TOWN OF ORLEANS, MA
WASTEWATER TREATMENT FACILITY AND EFFLUENT DISPOSAL

CONTRACT NO. 2019-01
SRF NO. 4486

JANUARY 2020

COVER SHEET AND LOCATION PLAN

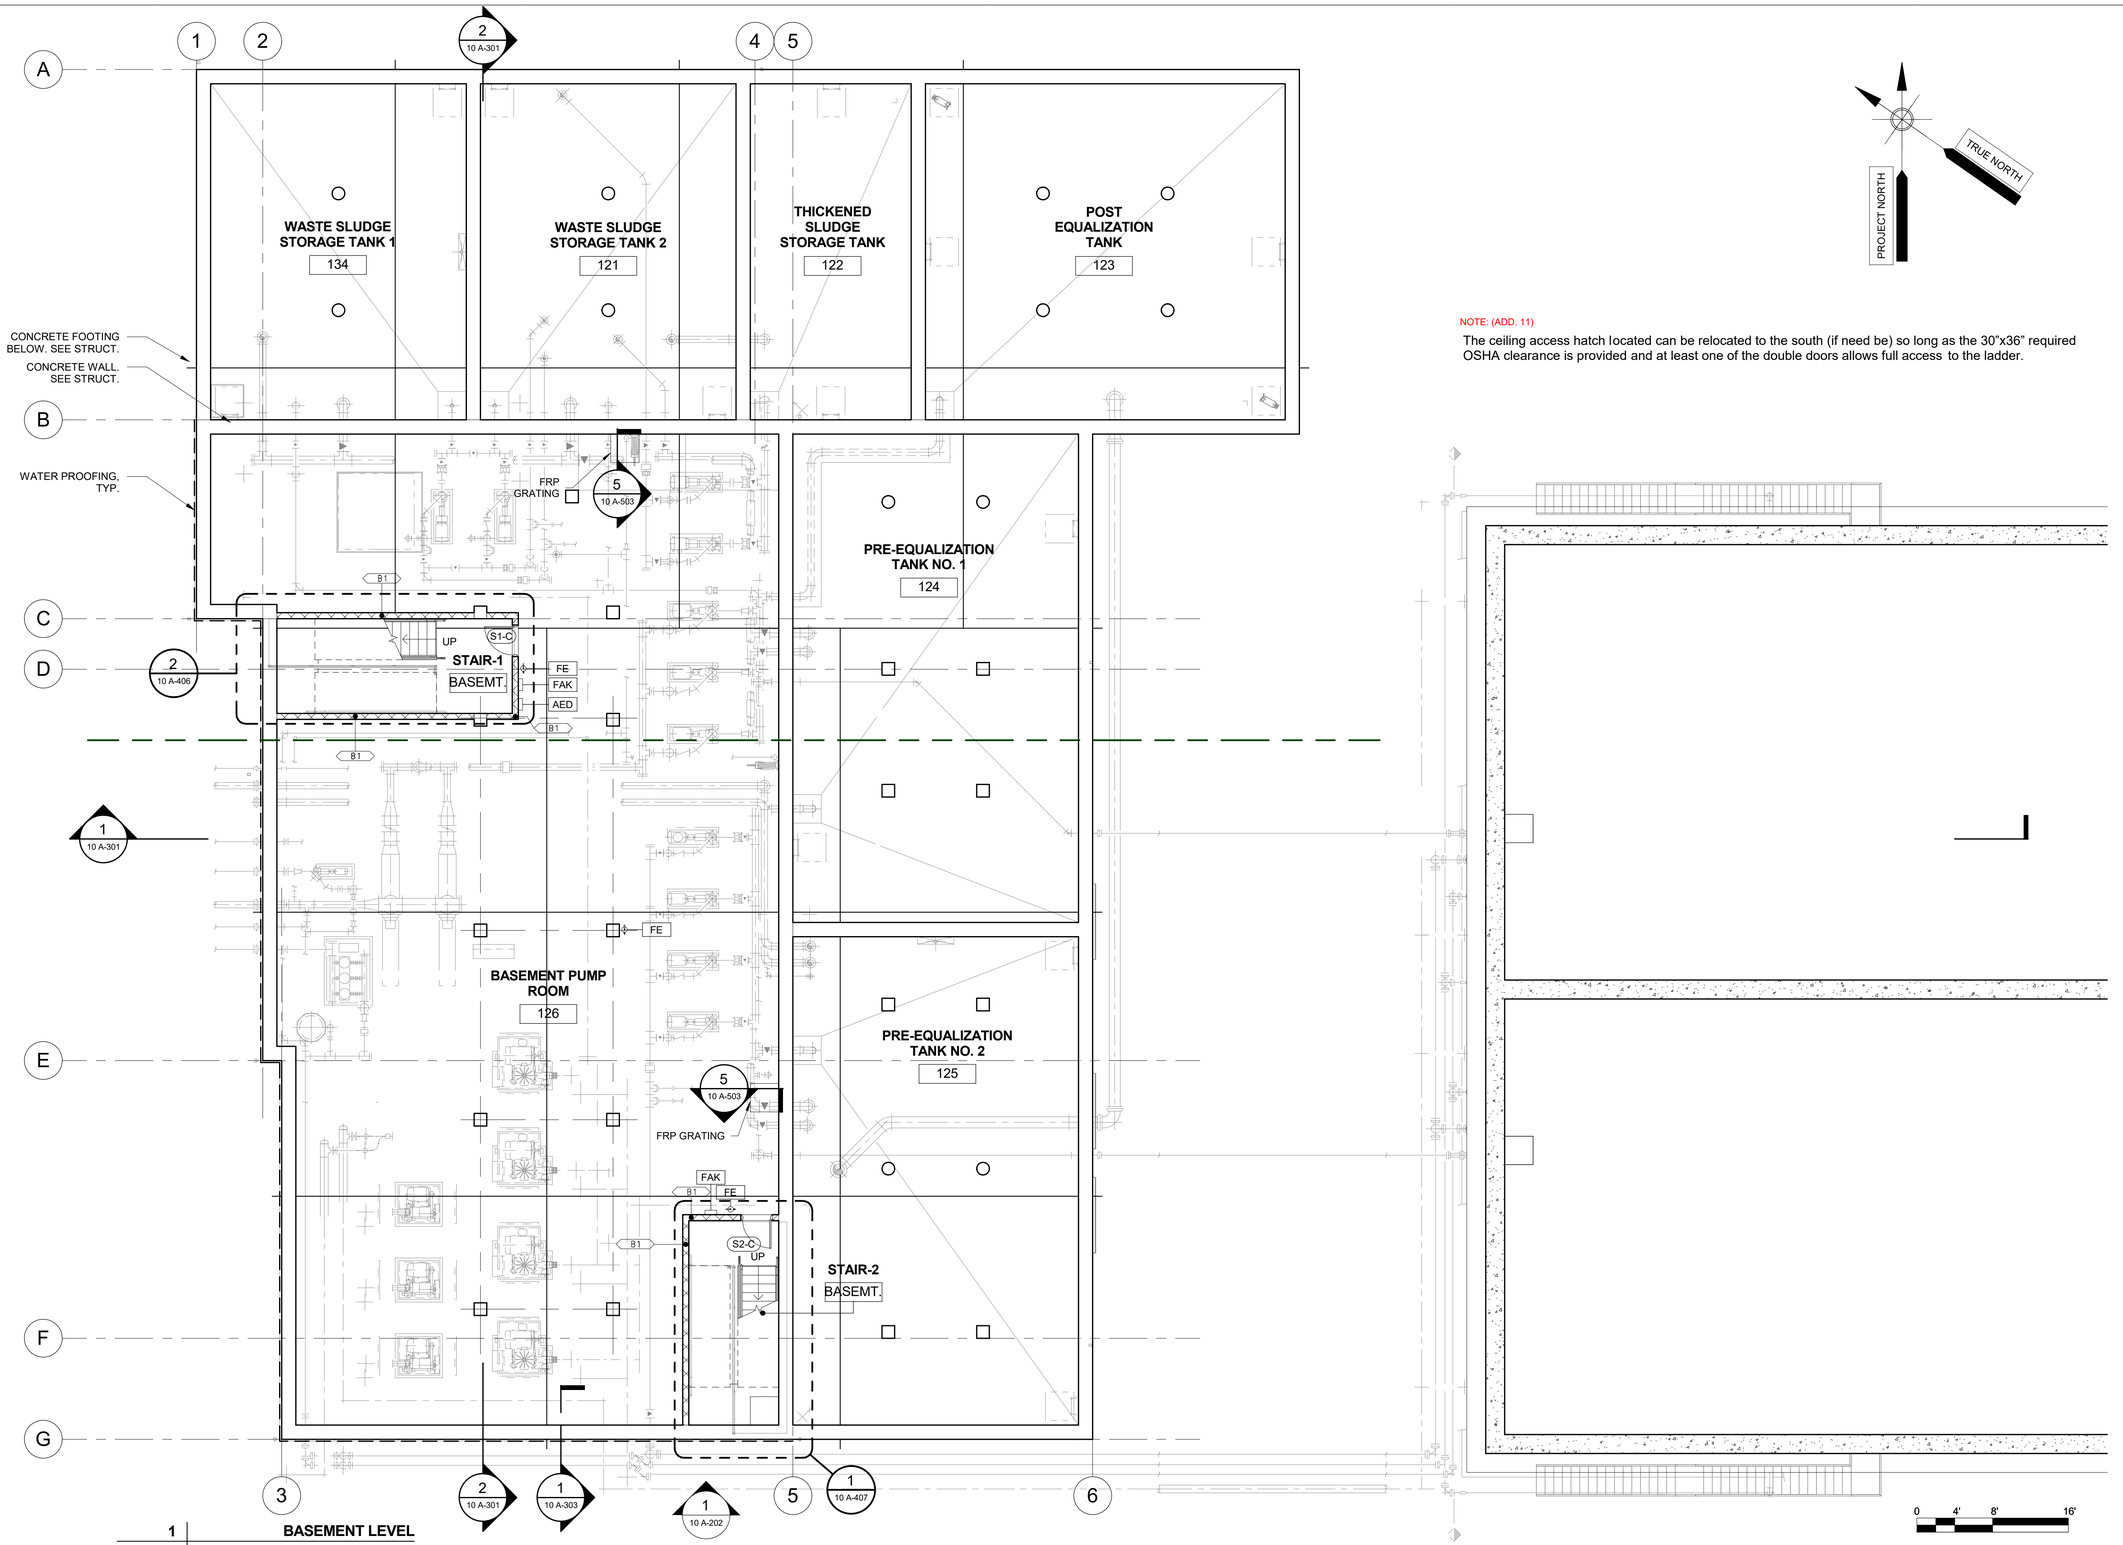
NOTE: (ADD. 11)

The ceiling access hatch located can be relocated to the south (if need be) so long as the 30"x36" required OSHA clearance is provided and at least one of the double doors allows full access to the ladder.

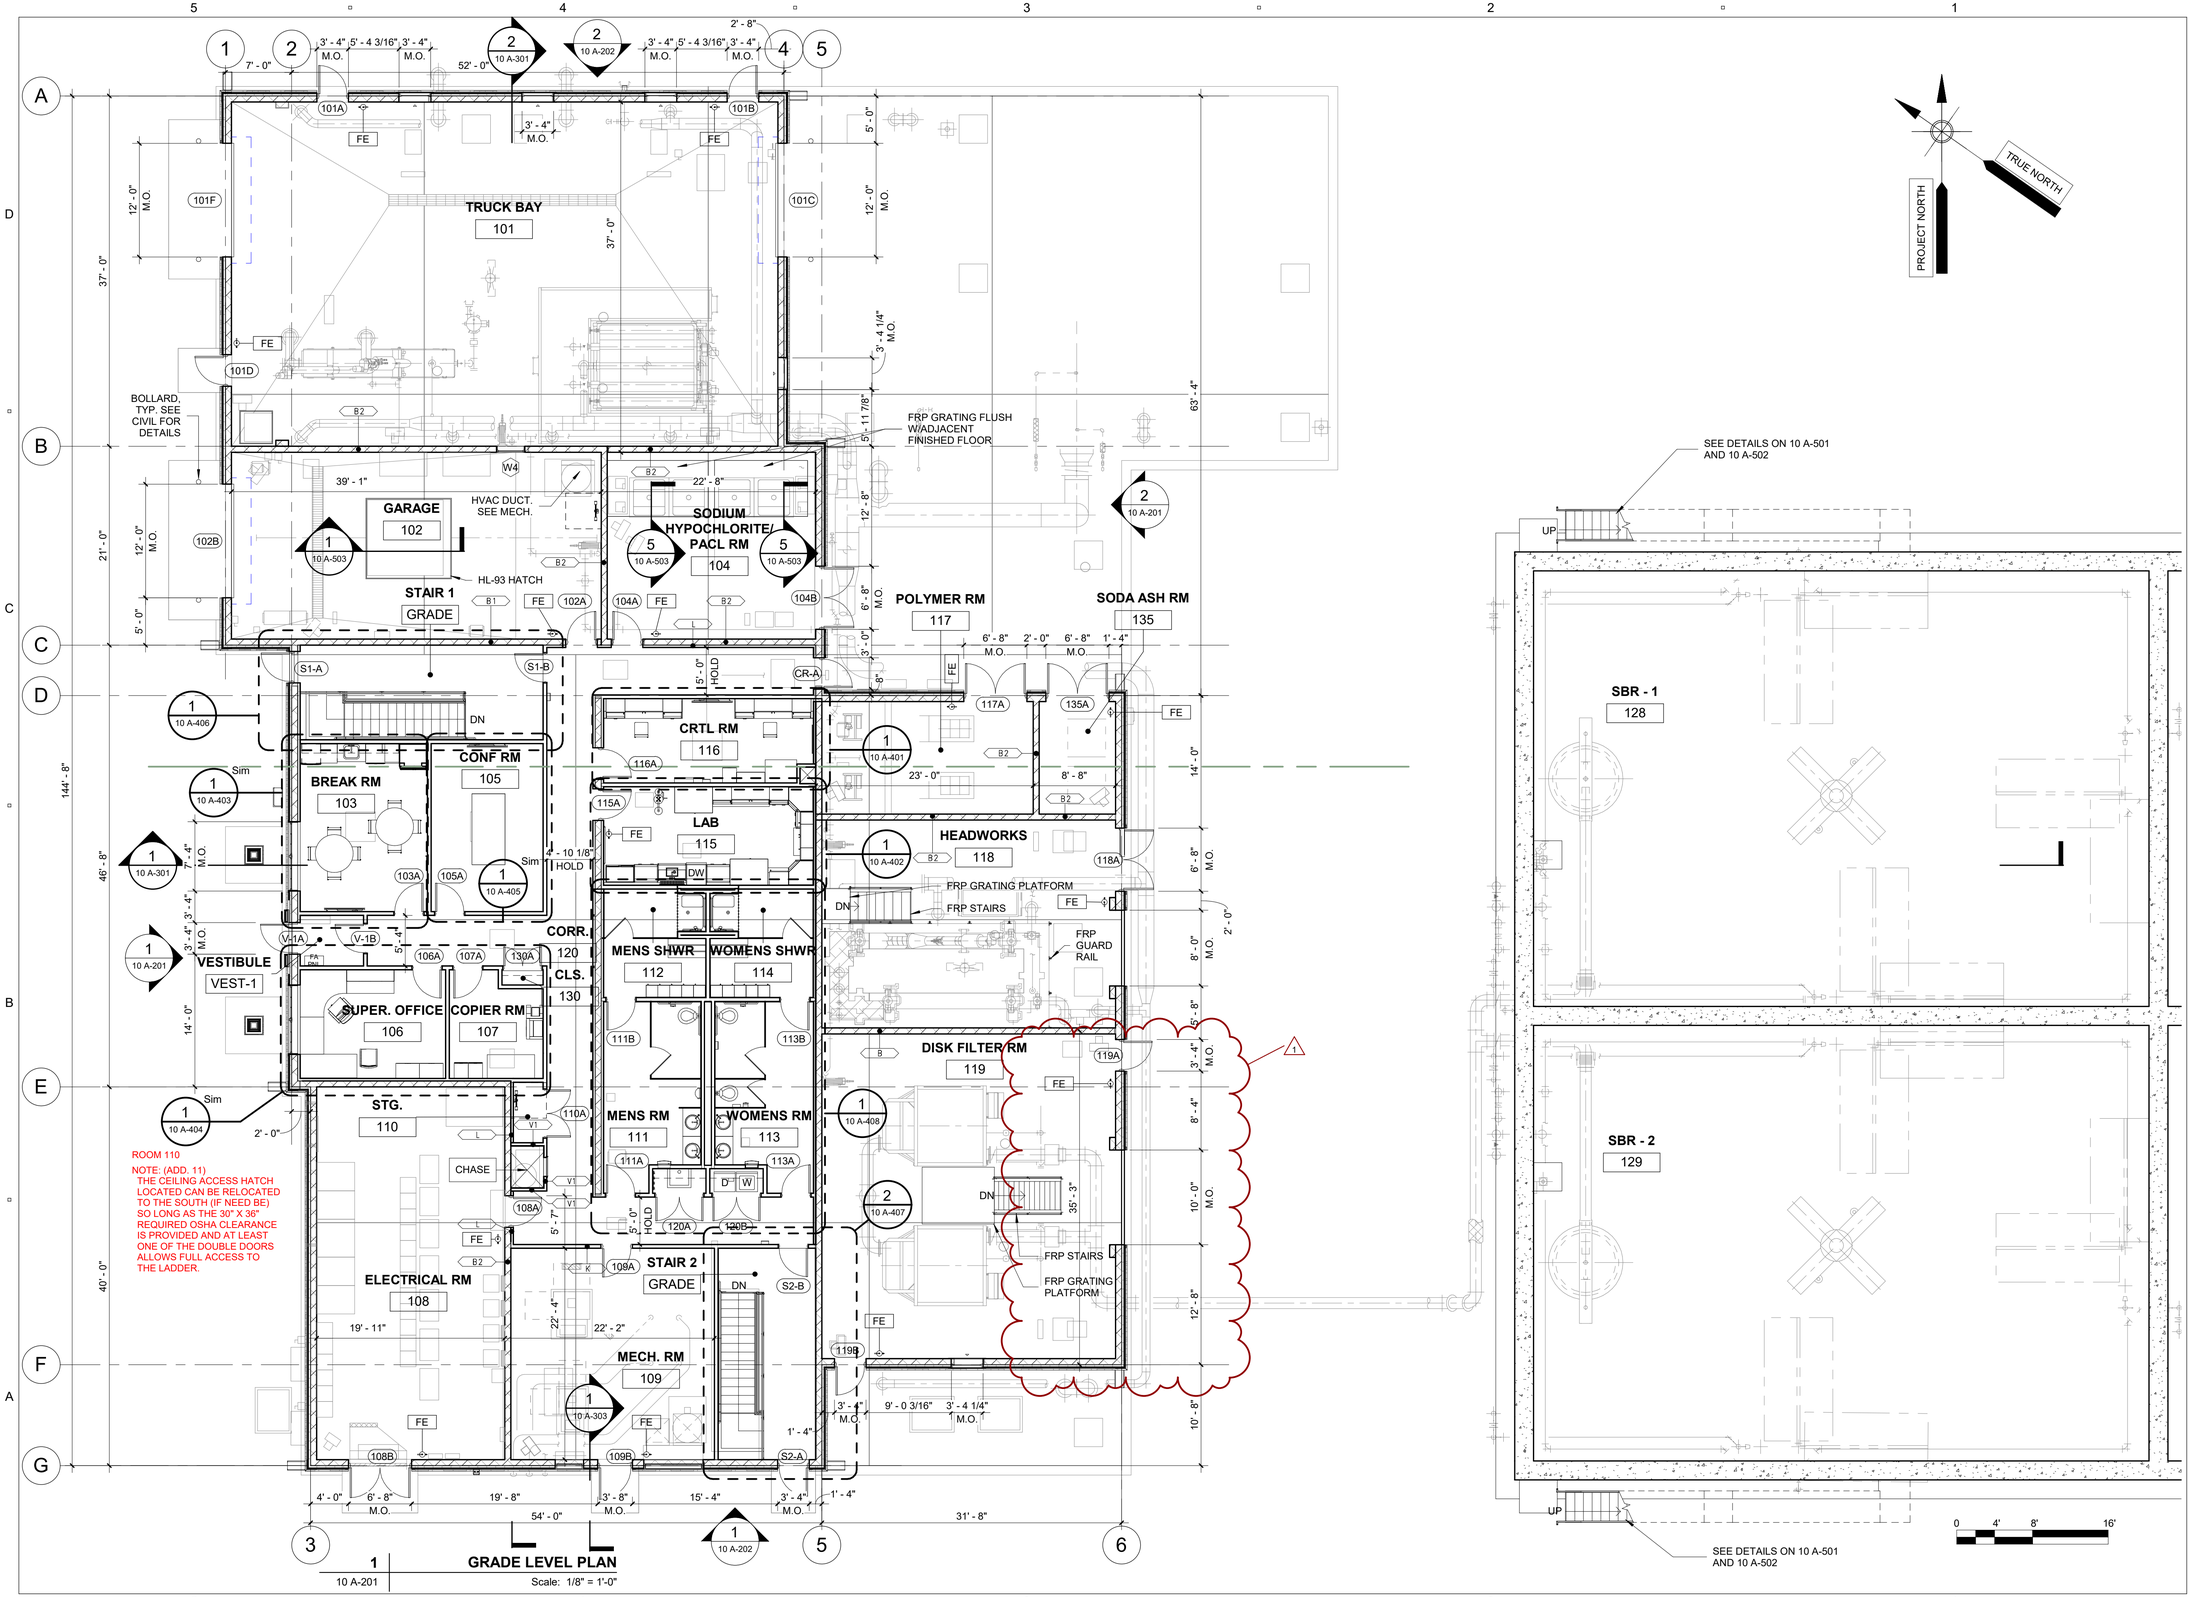
The location of the south chimney shall be in accordance with this Drawing. The location of the south chimney shown on DRAWING 10 S-105, ROOF LEVEL PLAN, shall be revised in accordance with this Drawing.

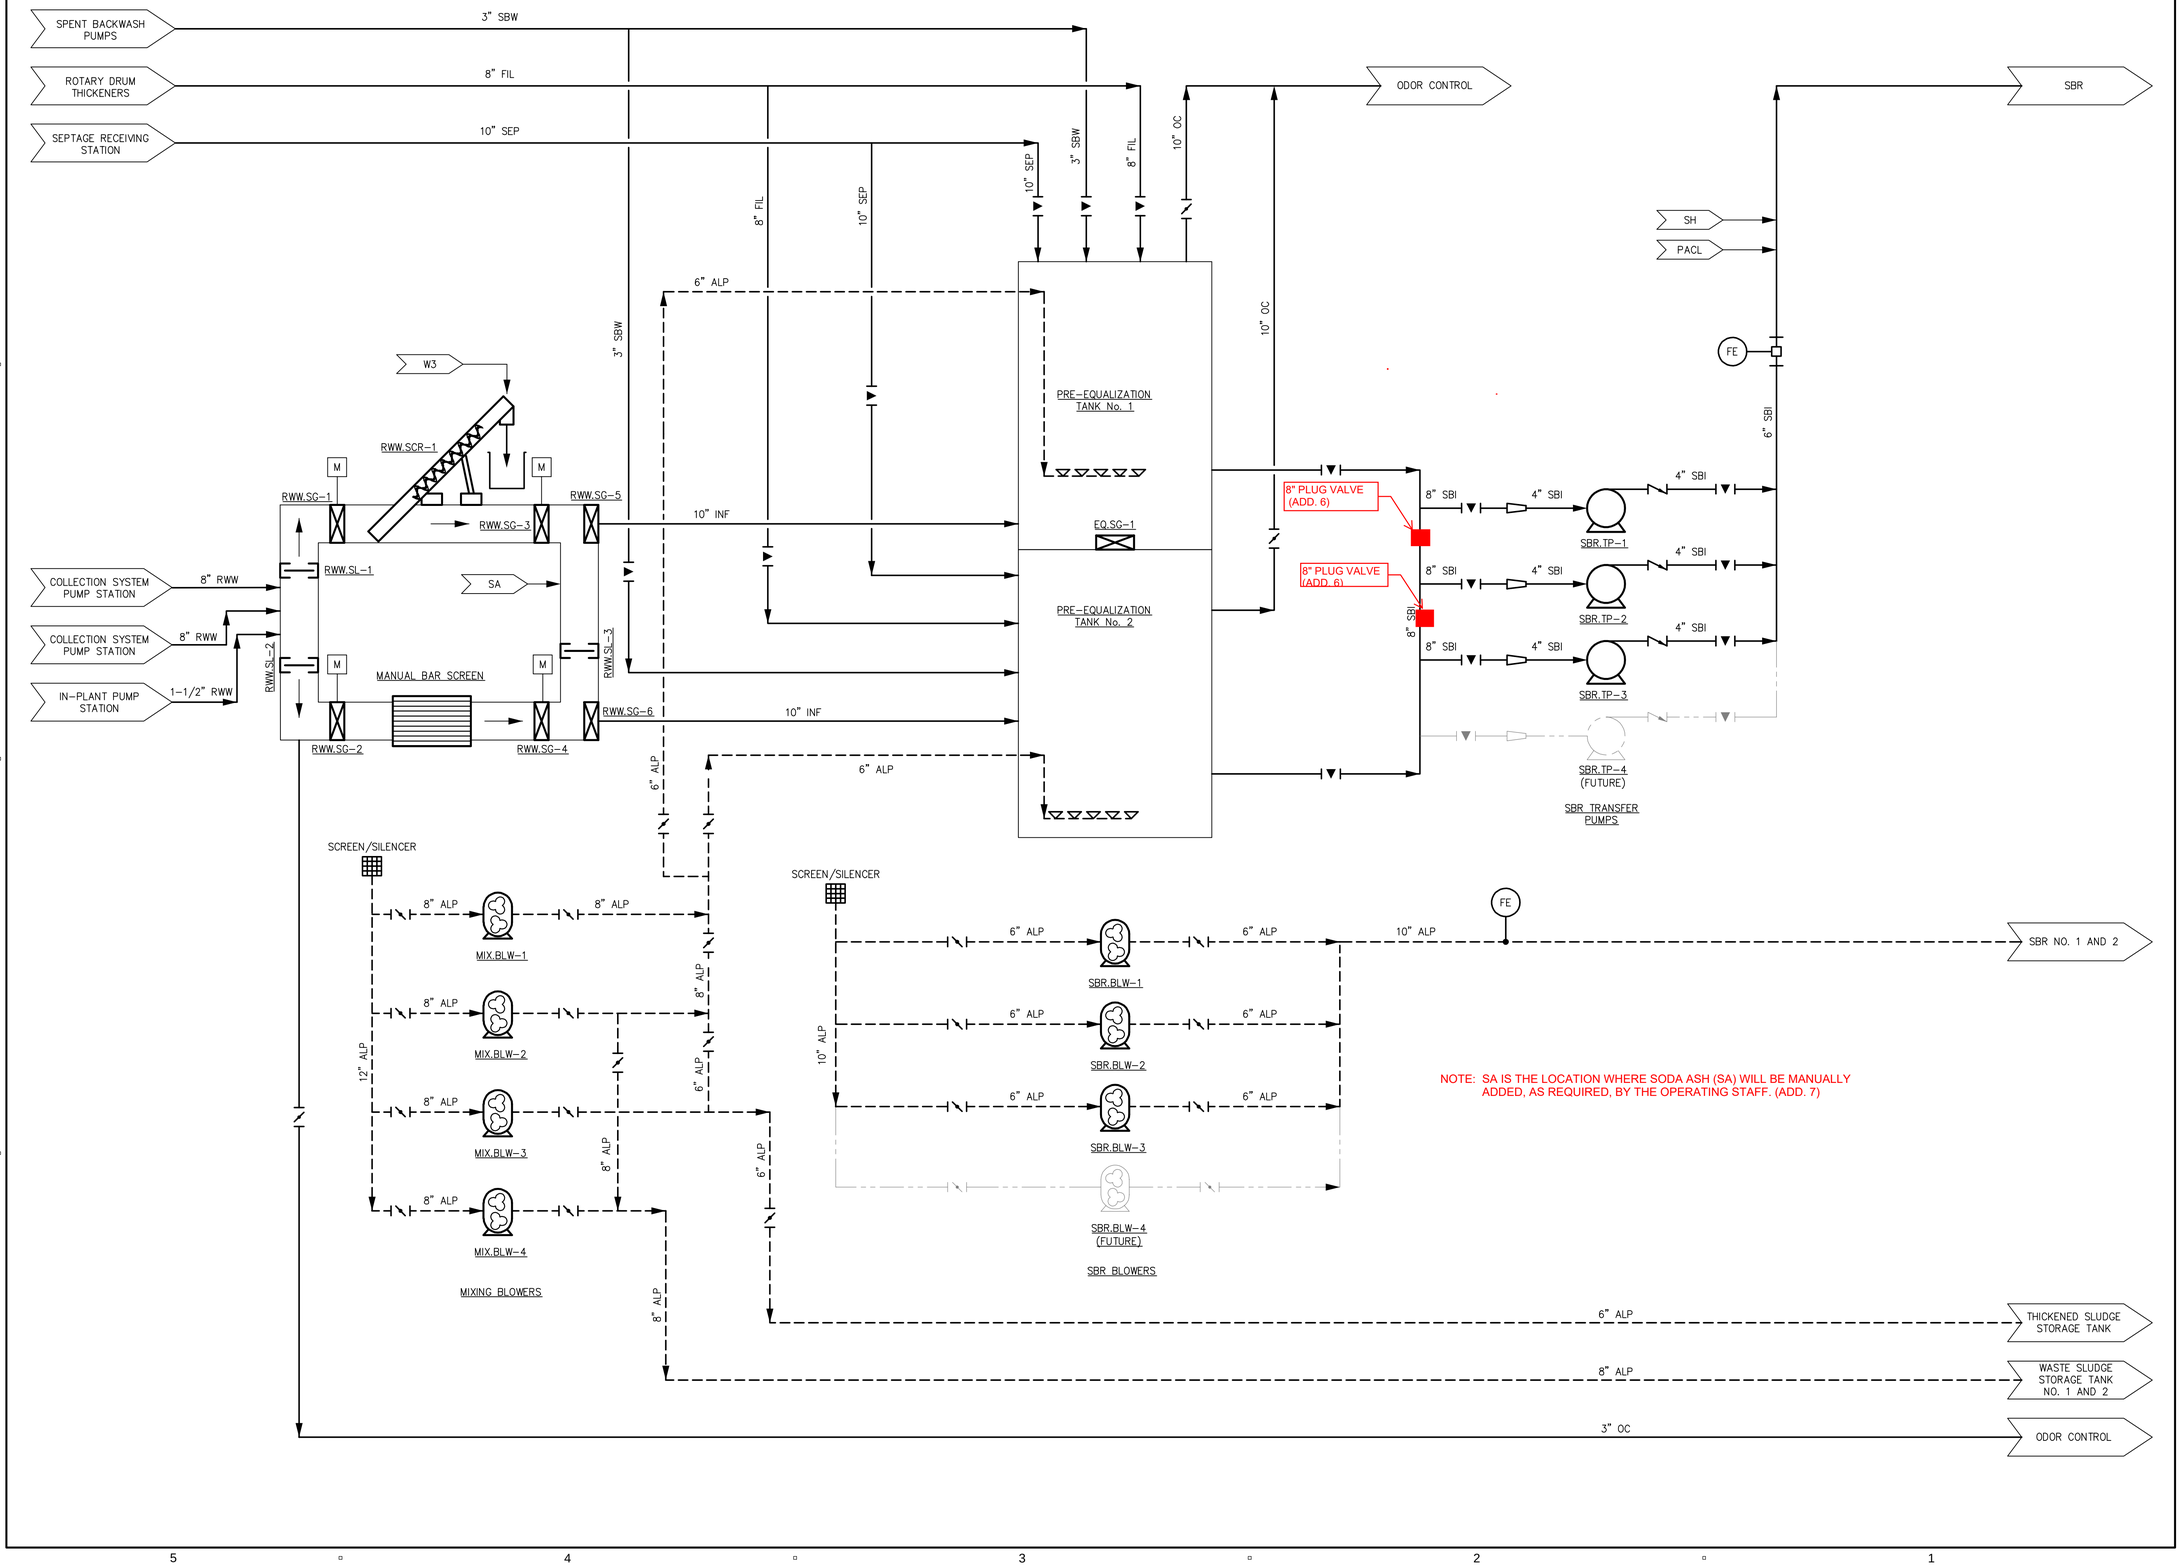
NOTE: SA IS THE LOCATION WHERE SODA ASH (SA) WILL BE MANUALLY ADDED, AS REQUIRED, BY THE OPERATING STAFF. (ADD. 7)
